FERN AVENUE
99-A-1-5

LONG ISLAND

As agreed yesterday, you may consider this letter as a lifting of the stop order issued with regard to your building on Fern Avenue, Long Island.

To erect one story frame cottage 12' x 18'

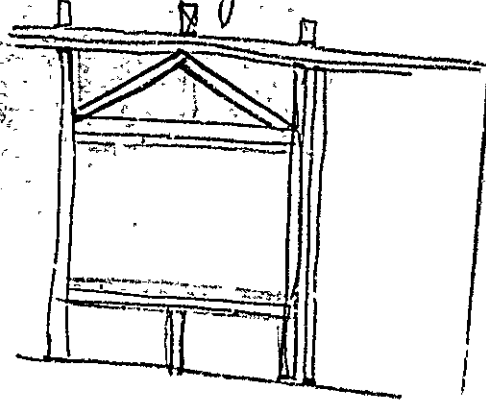
1. Provide substantial wood posts as indicated on sketch for a foundation for the building wherever the sill does not set directly upon ledge, this spacing of foundation supports calling for ten supports in all, - one at each of the four corners, one in the middle of each end and two intermediate posts on each long side so that the posts will be spaced approximately six feet from center to center. These posts are to go to a depth of four feet below the grade unless ledge is encountered at a lesser depth.

2. The present 2x4 nailing strip insecurely fastened to the sills are to be removed, the present 2x6 floor joists which are 24" from center to center are to be notched so that the 1x4 nailer may be replaced with the bottom of it flush with the bottom of the sill. Additional 2x6 floor joists properly cut and notched to rest upon this nailer are to be supplied between the present 2x6 joists getting a good bearing on the nailer.

3. The window and door openings are to be strengthened by some suitable means, perhaps by providing diagonal bracing to meet at the center of each opening beneath the plate above the openings, and if there is no sill piece beneath the window openings, one to be supplied and a short stud placed beneath the center.

4. It might be well also to strengthen the collar beams on account of the flatness of the roof.

Wood building
Foundation

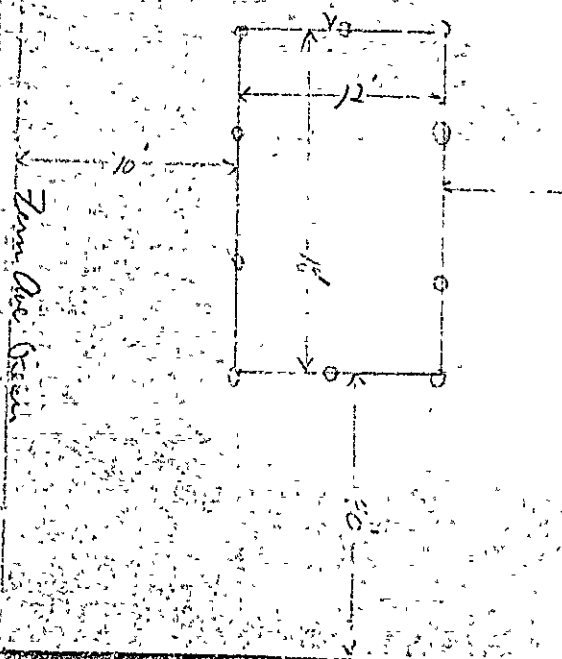
Stone piers have been laid up dry without mortar. Floor joists are 2x6, 24 inches on centers, instead of 2x8, 18 inches on centers. The studs rest on a 2x4 shoe which in turn rests on the floor joists instead of having the studs run down to the sills as required. A very unusual detail has been followed where the floor joists rest on the sills.

It will be necessary for you to get in touch with the undersigned at least by July 6, 1938 and advise how you propose to make the building comply with the Building Code.
